CITY OF MANZANITA Manzanita Classic Street Connection Project Addendum Number 2

DATE: May 7, 2025

ENGINEERING PLANS - ADDENDUM 2

Project Manager: MRL
 Drawn by: DTT
 Checked by: TWT

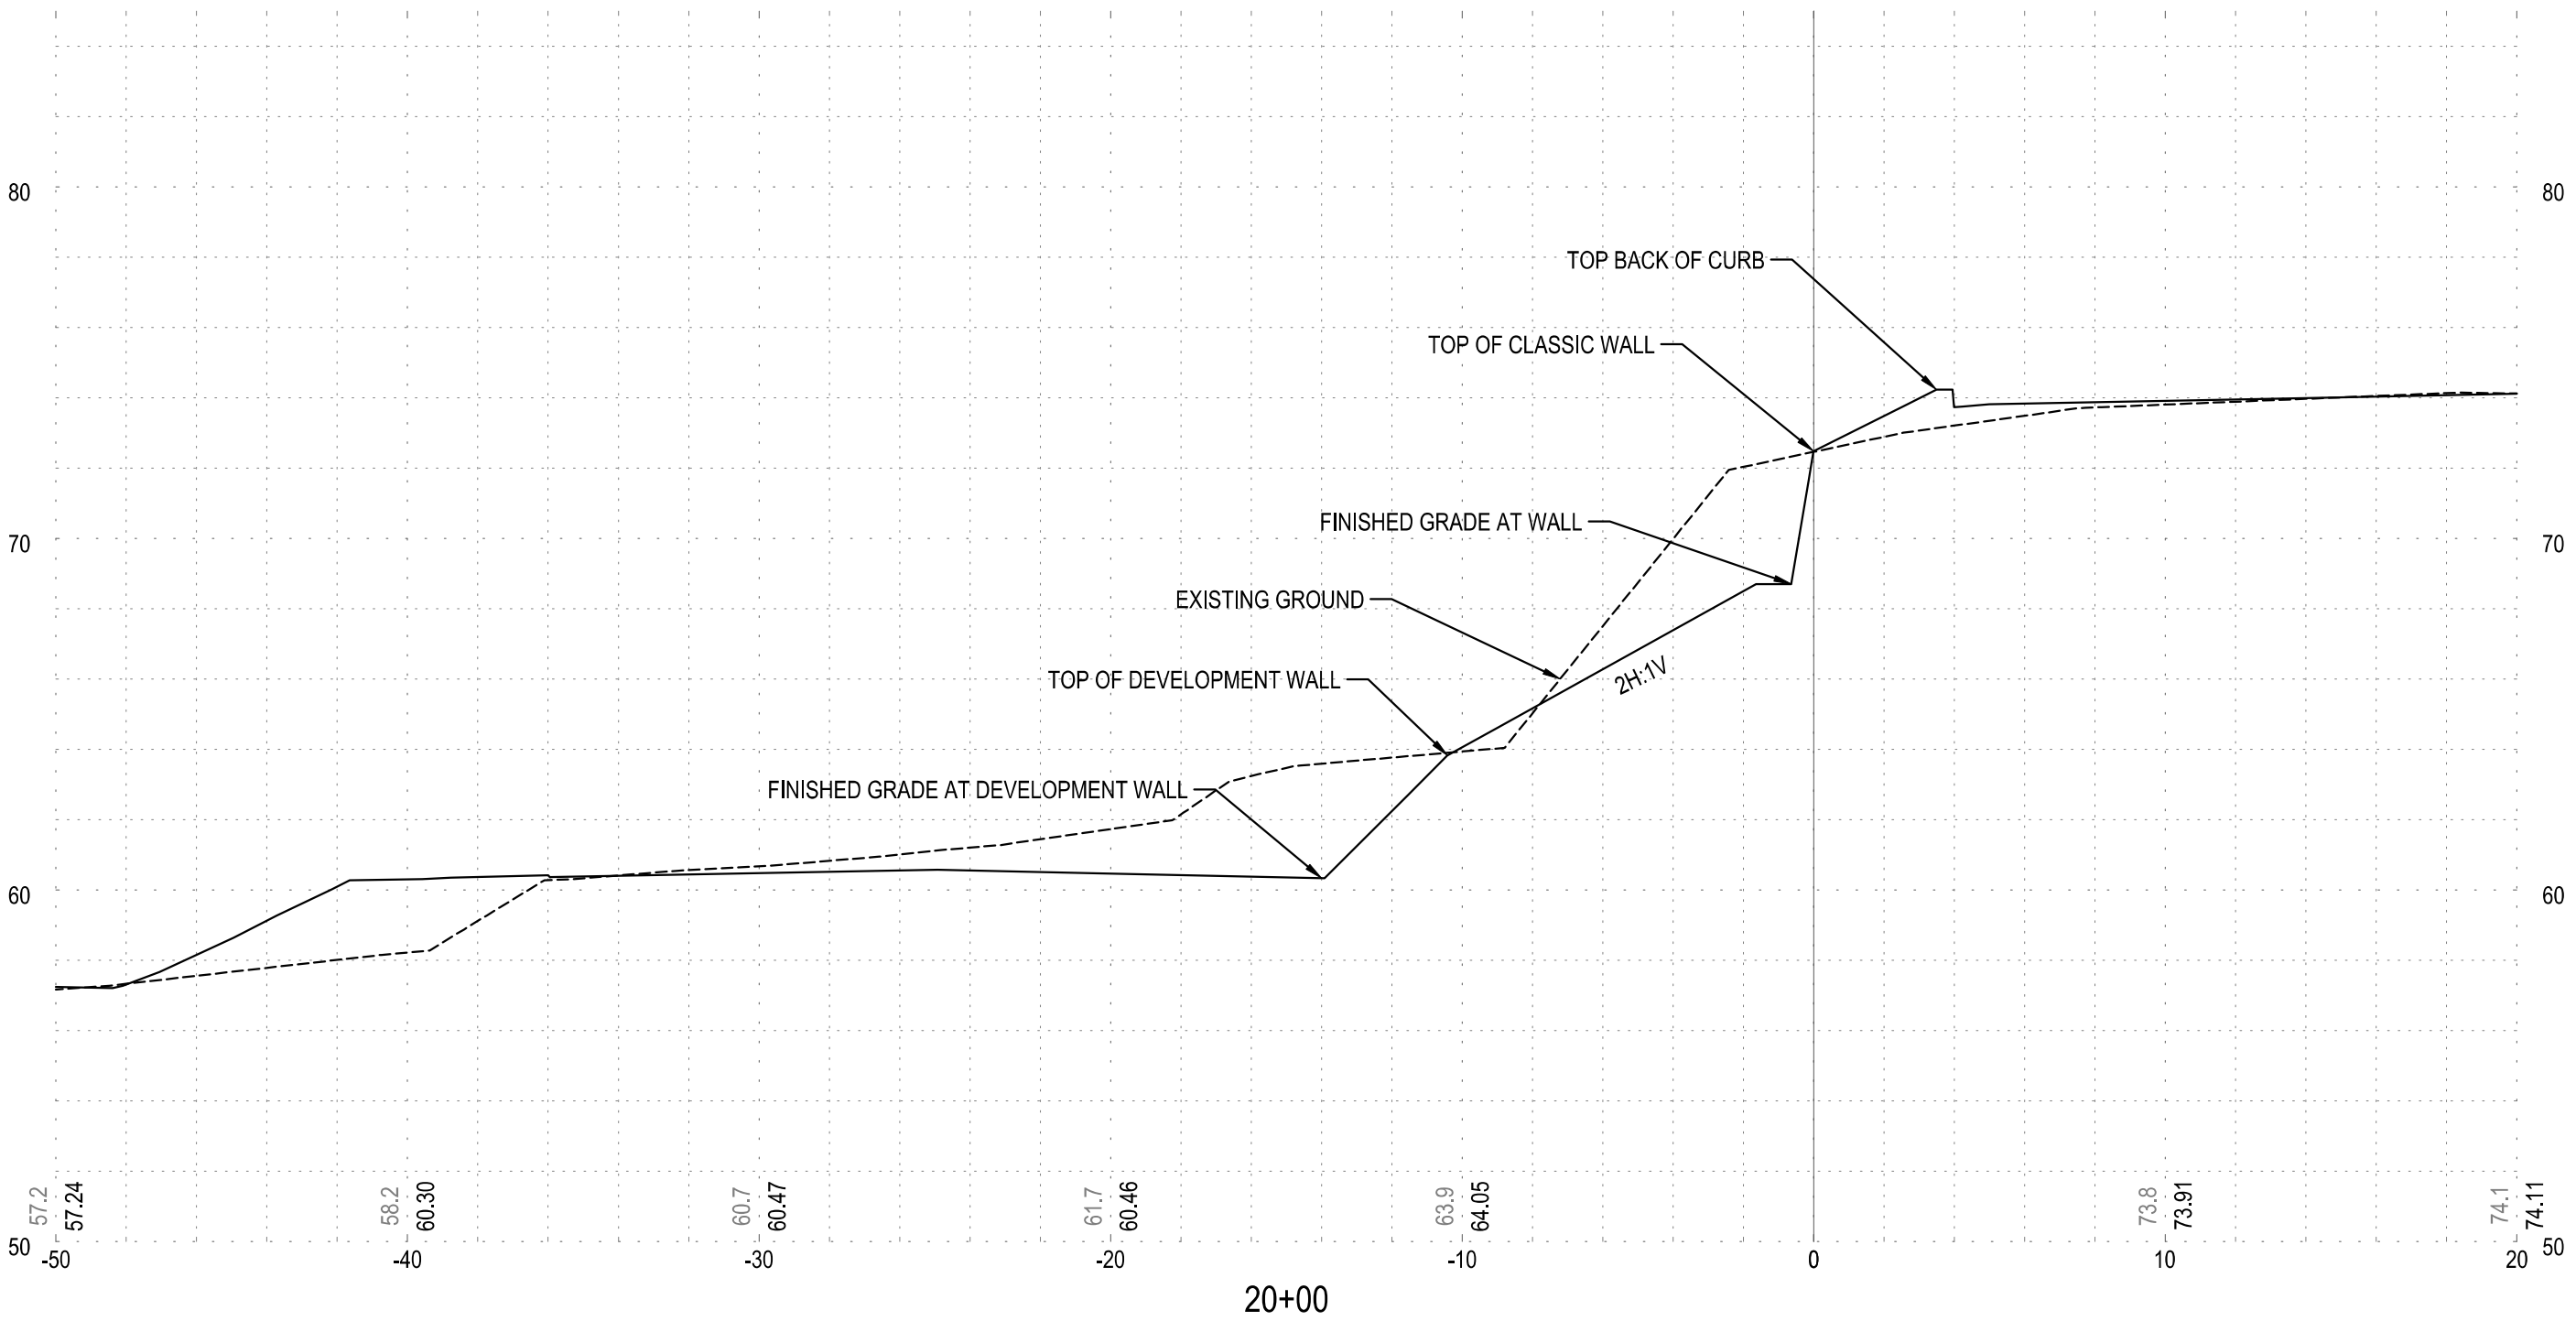
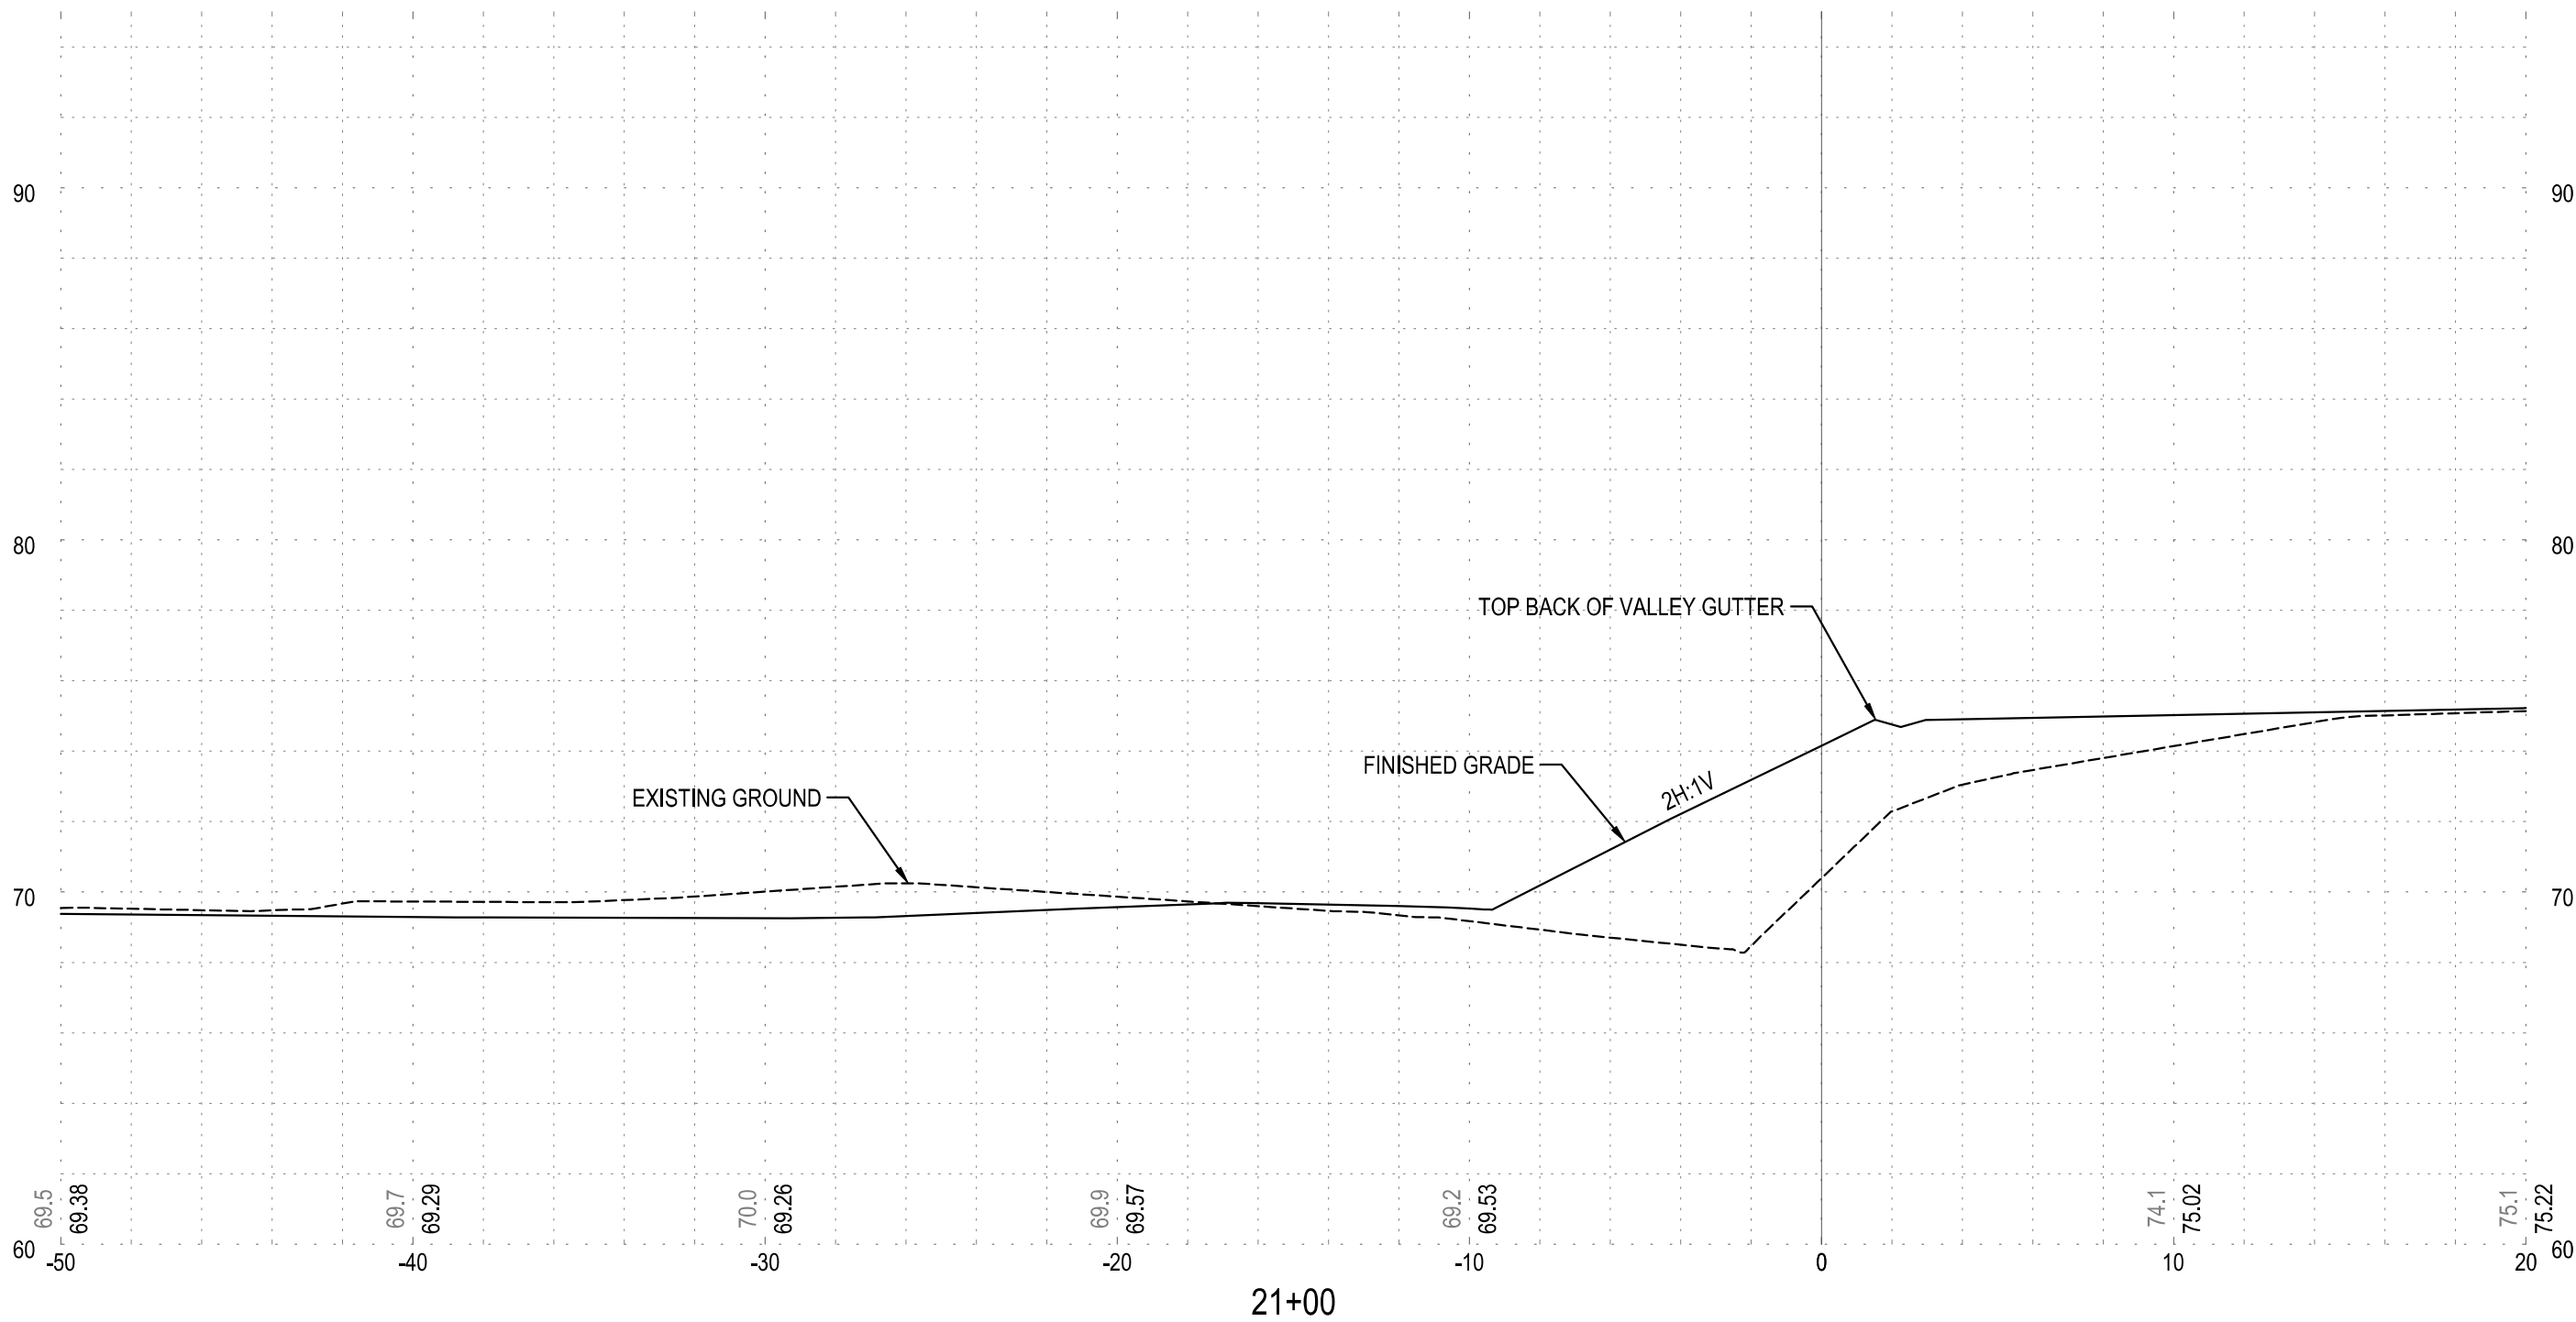
- **C601 – C603 (New)** – Retaining Wall Cross Sections: Added Cross section plan sheets along the retaining wall to help illustrate cut and fill needs along the wall.
